Drainage Letter

See comments on Drainage
report submitted under file #
SF-21-042 Final Plat

Viewpoint Estates

Filing No. 2

MVE PROJECT 61099
MVE DRAWING EX-DRN

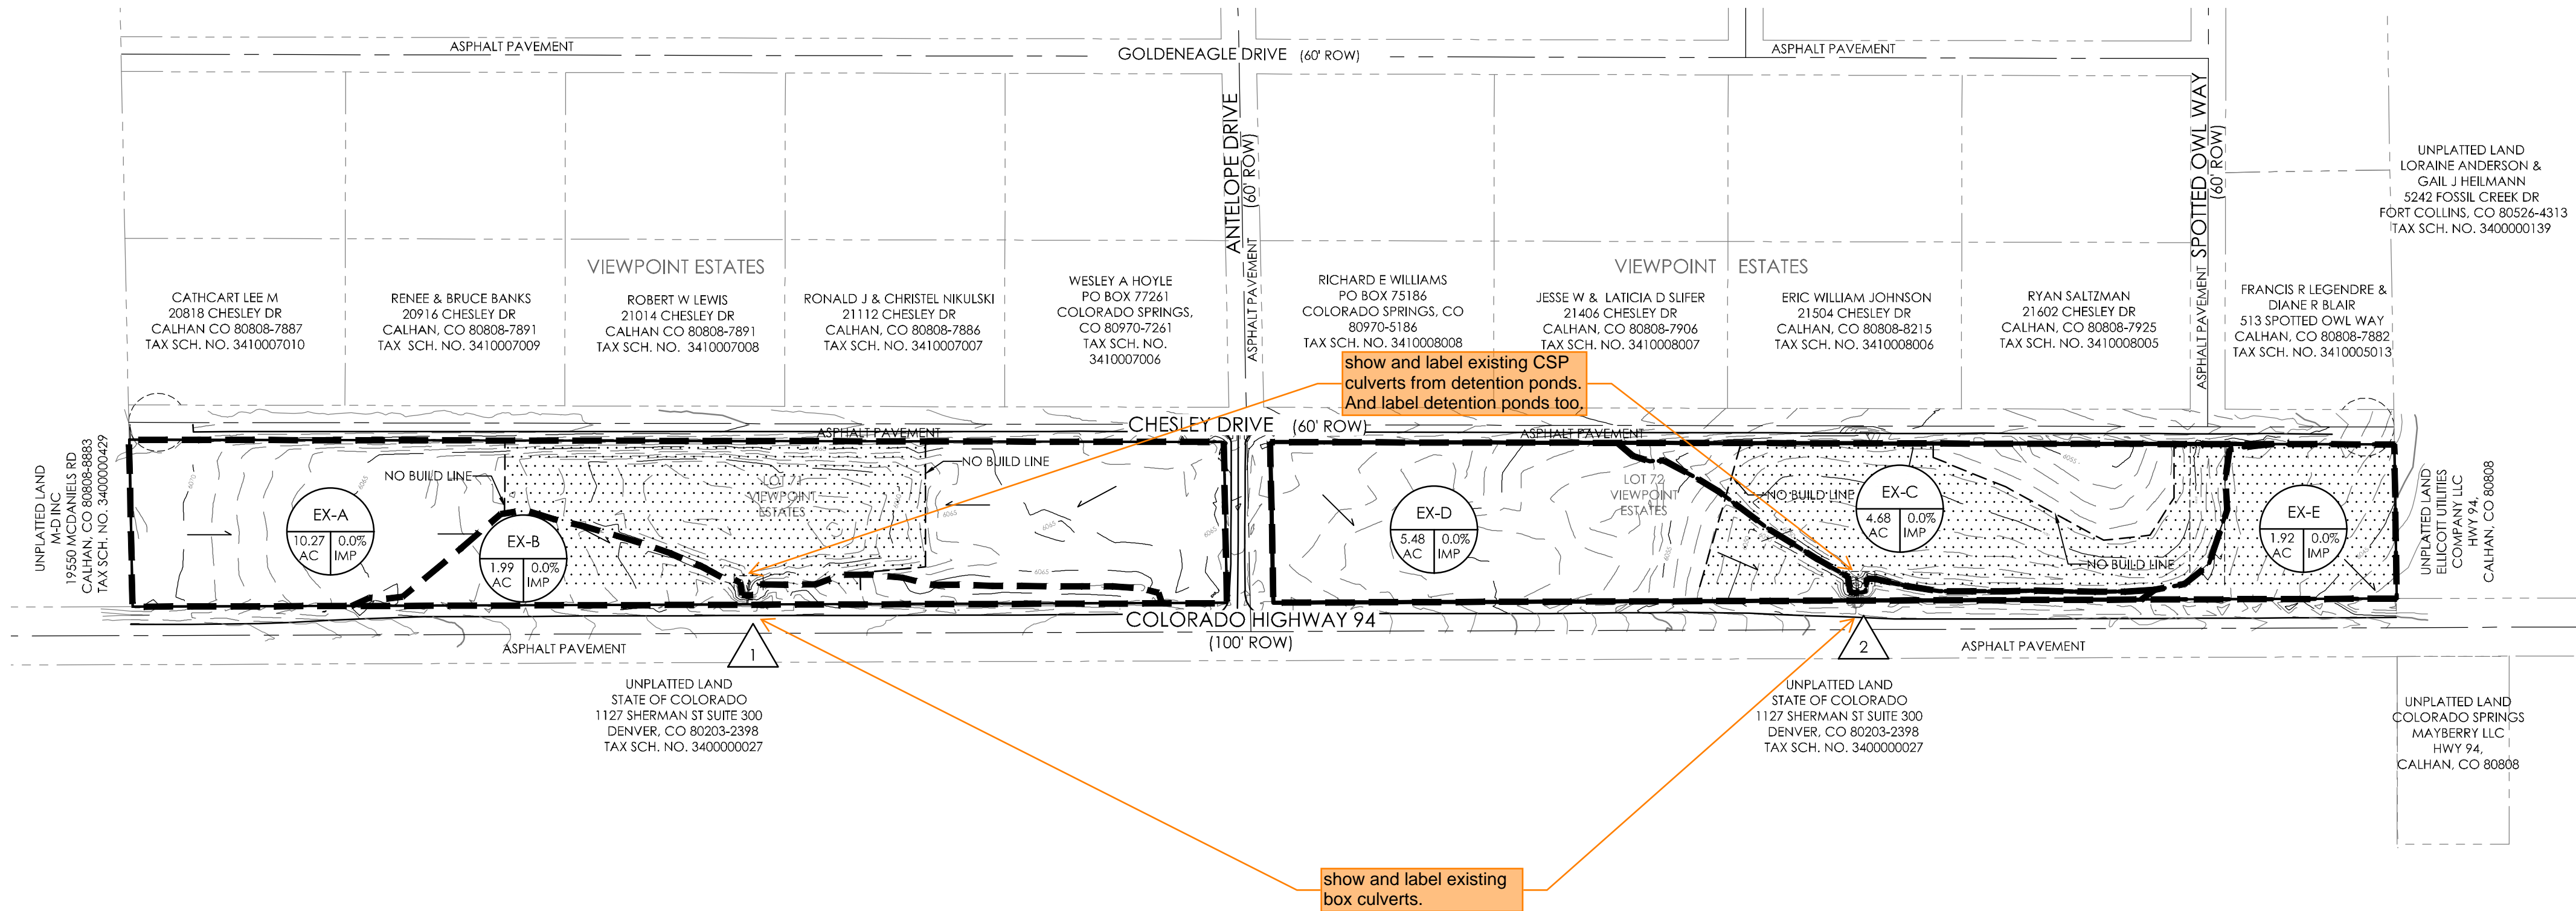
What is size? And show on map.

What is size? And show on map.

MVE PROJECT 61099
MVE DRAWING PP-DRN

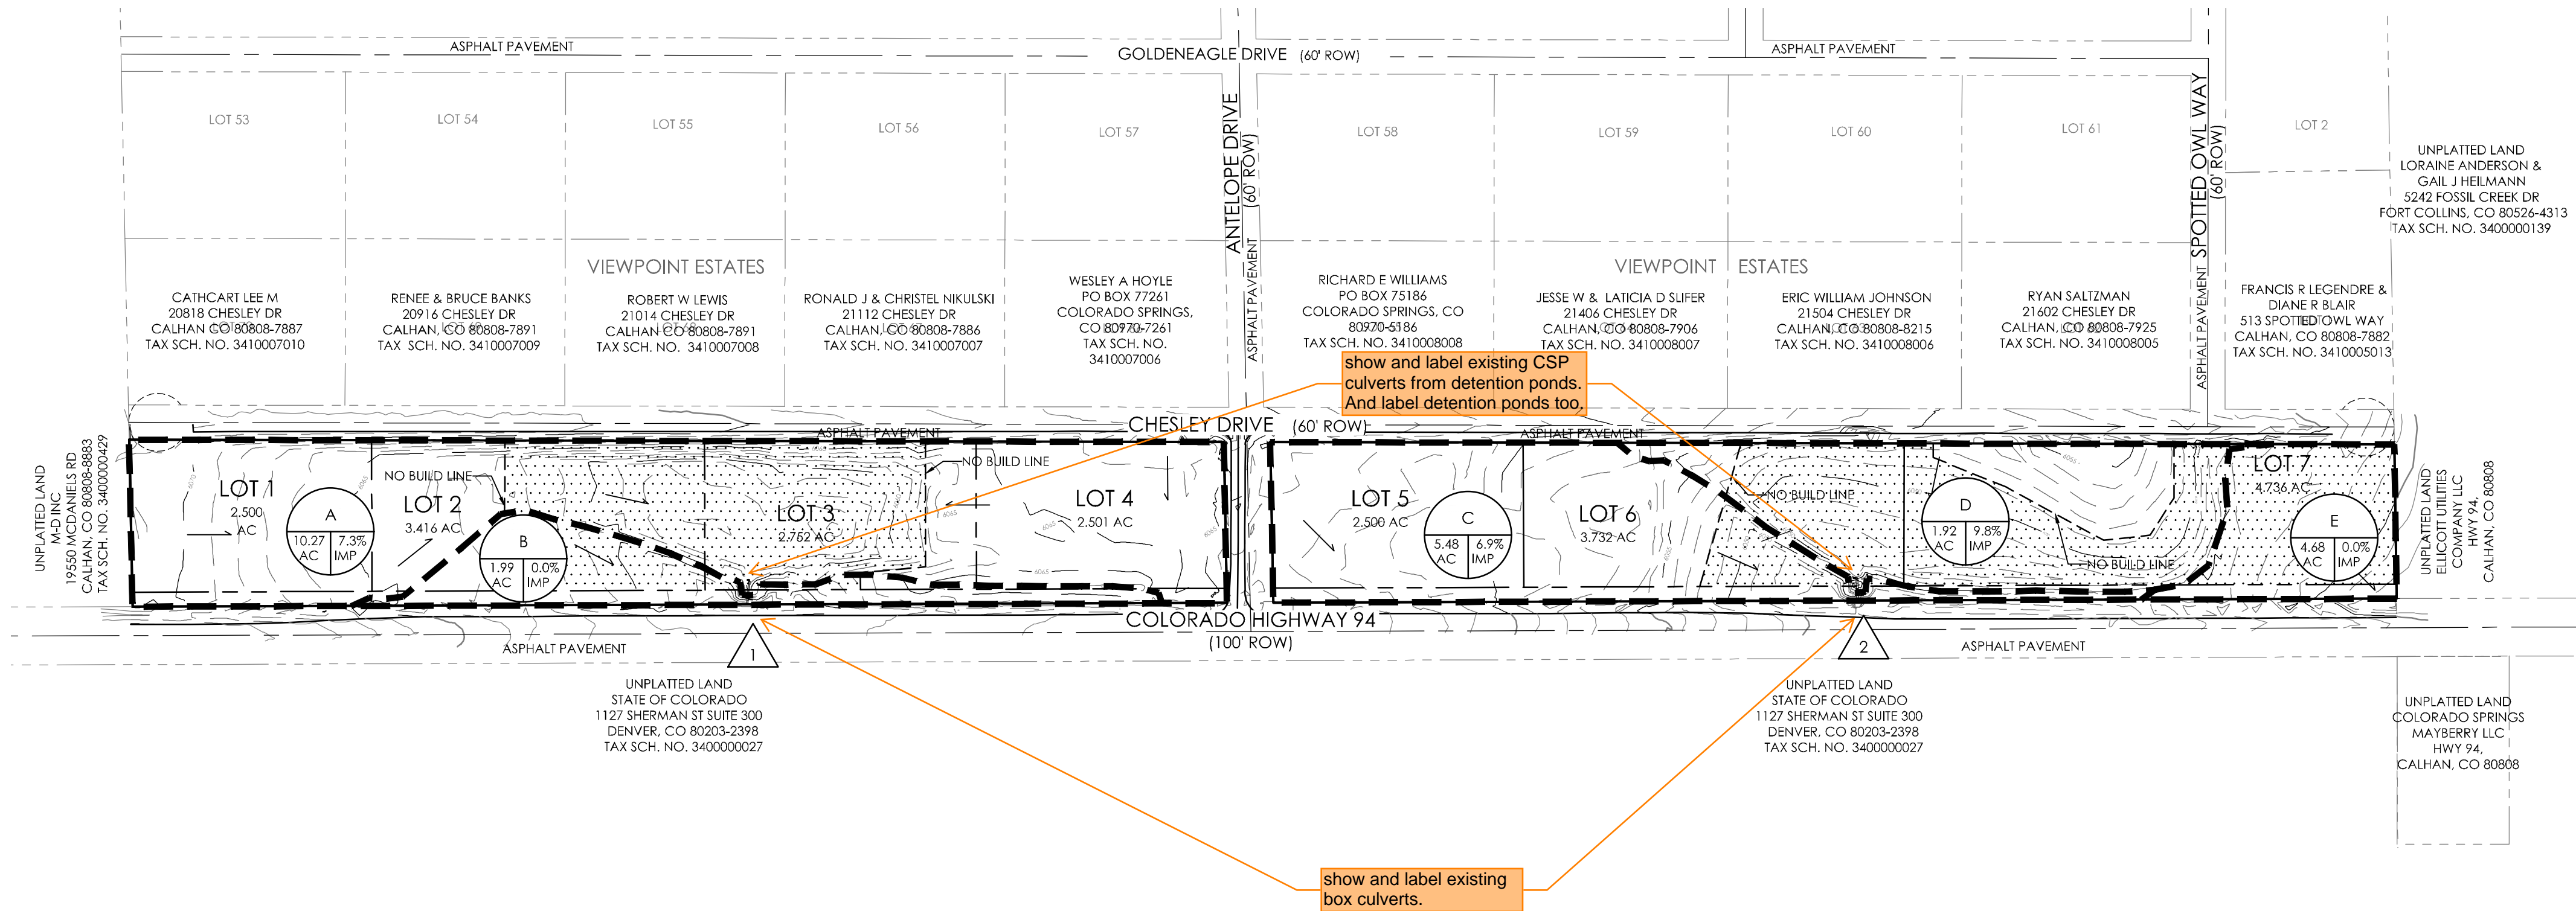
Actually 33" CSP per 1998 construction drawings (sheet 21 of 24). Address why there is/was a change or revise report text and maps accordingly.

What is size? And show on map.
